Project	IEEE 802.16 Broadband Wireless Access Working Group < http://ieee802.org/16 >	
Title	Power Balancing for MIMO Precoder	
Date Submitted	2009-07-15	
Source(s)	¹ Hsuan-Jung Su, Chung-Pi Lee, Yu-Han Yang, Chun-Yao Chen, Wei-Shun Liao, NTU Ren-Jr Chen, Chung-Lien Ho, Chang-Lan Tsai, Zheng Yan-Xiu, ITRI	Voice: ¹ +886-2-33663600 E-mail: ¹ hjsu@cc.ee.ntu.edu.tw * http://standards.ieee.org/faqs/affiliationFAQ.html >
Re:	IEEE 802.16m-09/00028 “Call for Comments and Contributions on Project 802.16m Amendment Content”	
Abstract	This contribution addresses the high PAPR issue related to MIMO precoding and IFFT. It is suggested that a general remedy to the PAPR issue without introducing signal distortion or side information feeding forward should be considered in 802.16m. A method based on constellation shaping to balance the signal power, such that the high PAPR caused by precoding and IFFT can be reduced, is also provided in this contribution as an example of such general remedies.

Power Balancing for MIMO Precoder

Figure 514 -- UL MIMO architecture

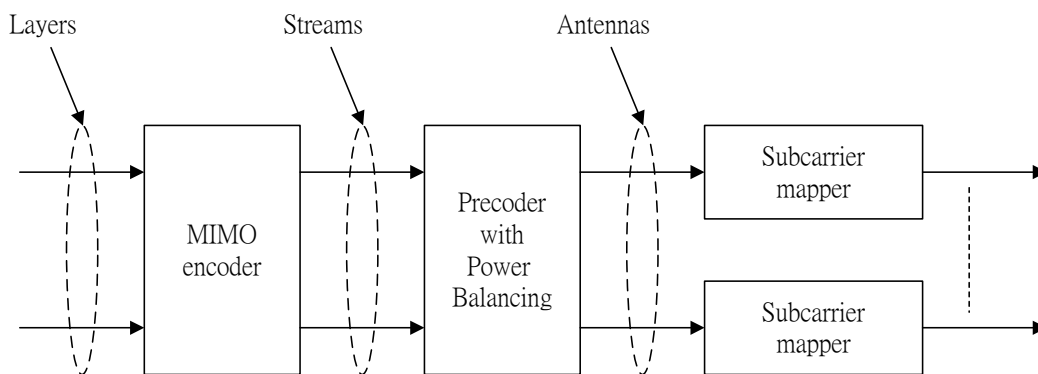
Modify Figure 514 as follows.

Figure XXX – Precoder with Power Balancing

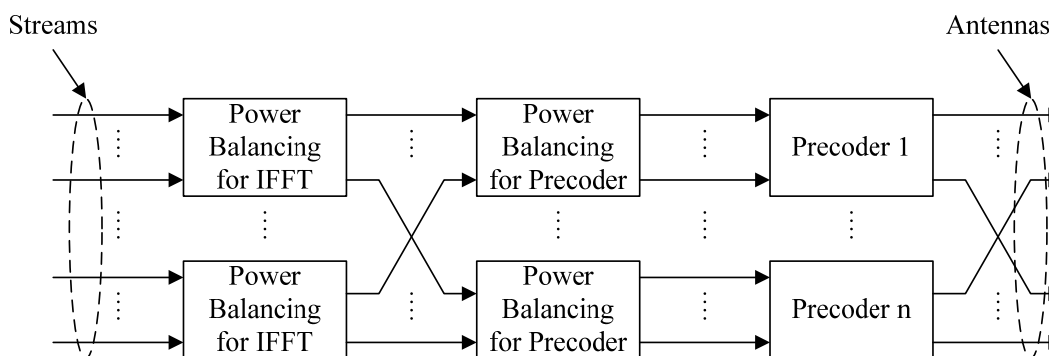
Add the following section on power balancing for the precoder and IFFT.

15.3.10.1.2.3 Power Balancing

Power balancing can be performed to alleviate the high peak power problem caused by the precoder and IFFT. The precoder block with power balancing is shown in Figure XXX. The power balancing operations are in the order of power balancing for IFFT first, then power balancing for precoding. Power balancing for precoding is an integer-to-integer mapping which is an approximation of the inverse of the precoding matrix, where integer means Gaussian integer defined on the grid of the signal constellation. For any precoding matrix, the integer-to-integer mapping of the power balancing operation is factorized into a series of Integer Reversible Matrix Mapping (IRMM)
